## Diversified Metal Fabricators Service Bulletin SB 2046

<b>Title</b>	Roto 180 Hitch Structure Reinforcement
<b>Document No.</b>	SB 2046
<b>Issue Date</b>	1/25/06 (WAK)
<b>Units Affected</b>	Roto-180 installed with Hitch Structure at DMF in 2005. All units should be checked and repaired as described below. Units must not tow until hitch has been inspected and repaired if necessary.
<b>Purpose</b>	To address an installation error in Pintle Hitch Structure.

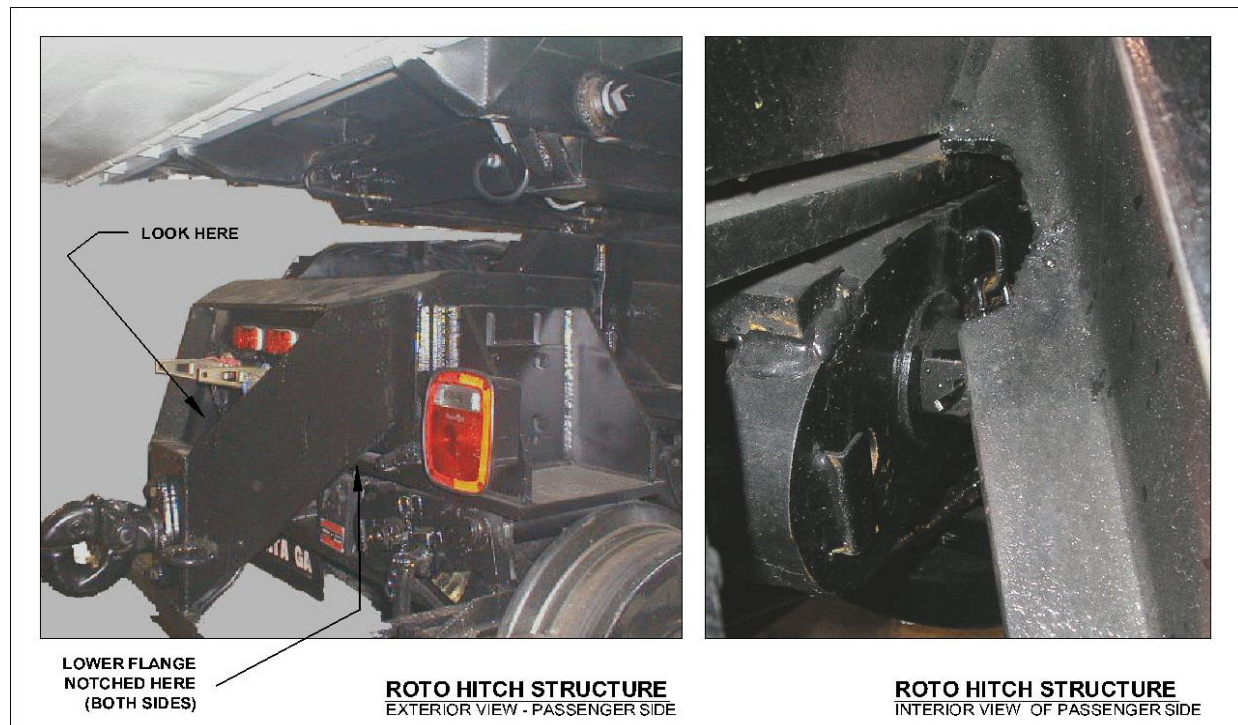
Notches were torch cut in the lower flanges of the main channel beams for clearance. These notches create a significant stress concentration and can cause a structural failure. Inspect units as shown below:

### Repair Affected Units

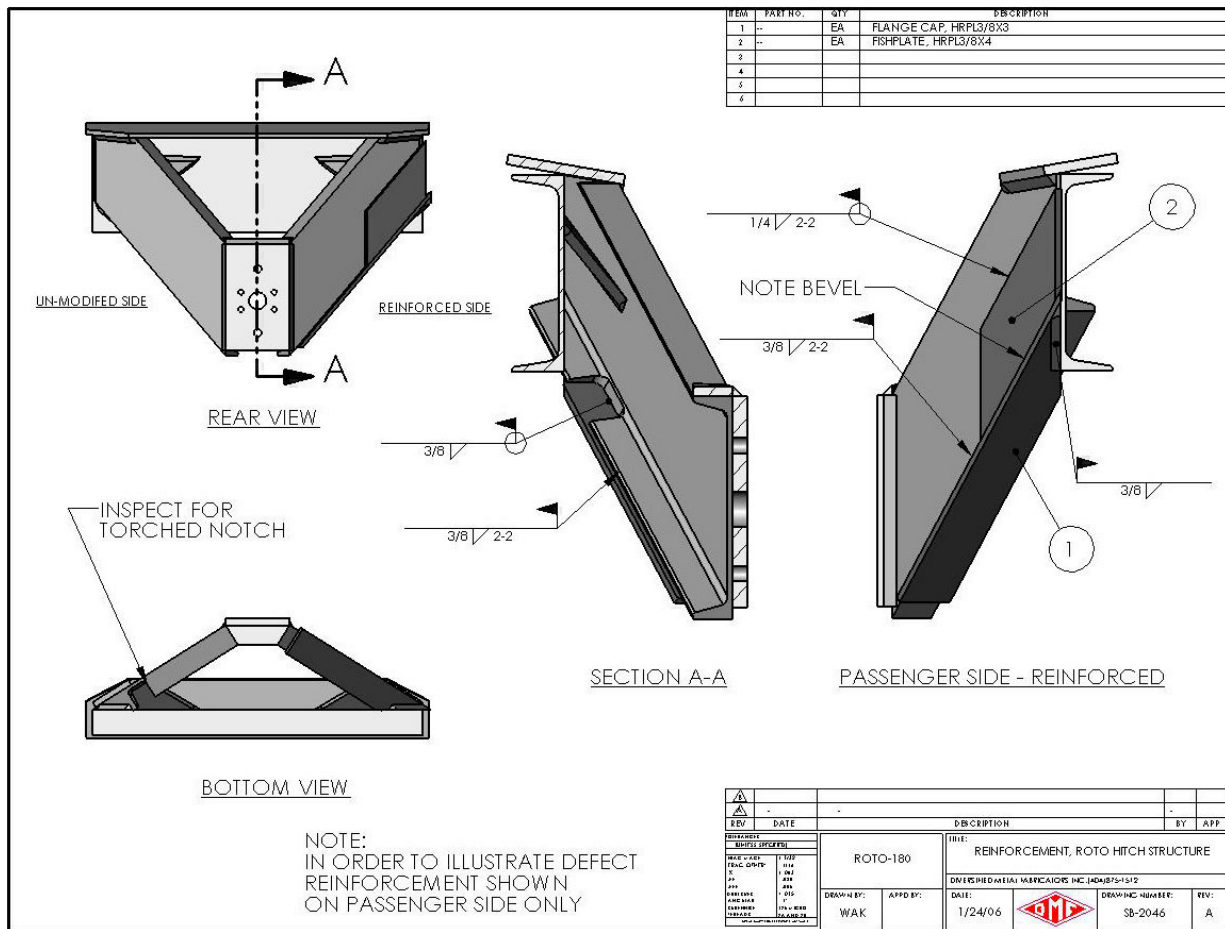
- Inspect area around notch, looking for cracks originating from notch area. Contact DMF if any cracks extend more than 1/2" into the web of the channel.
- Any cracks should be ground and welded.
- Surfaces to be welded should be cleaned and ground free of paint.
- Tack plates as shown, grind to fit if necessary.
- Weld as shown in attached drawing.
- DMF will supply flange reinforcement and fishplate. Note orientation of beveled edge on fishplate.
- Prime and paint to match.
